HARTING Product Change Notification

PCN/20/024/C+N-US

Title: Han-Modular Shielding Frame 24B

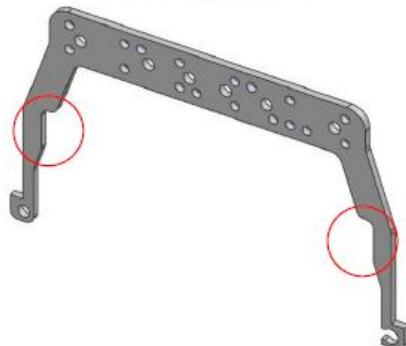
The Han-Modular® shielding frame size 24B will have two additional dimensional cuts shown on the following drawing:

These two cuts improve handling and terminating modules for larger wires at the outer positions for the Han-Modular® Hinged Frame 24B size.
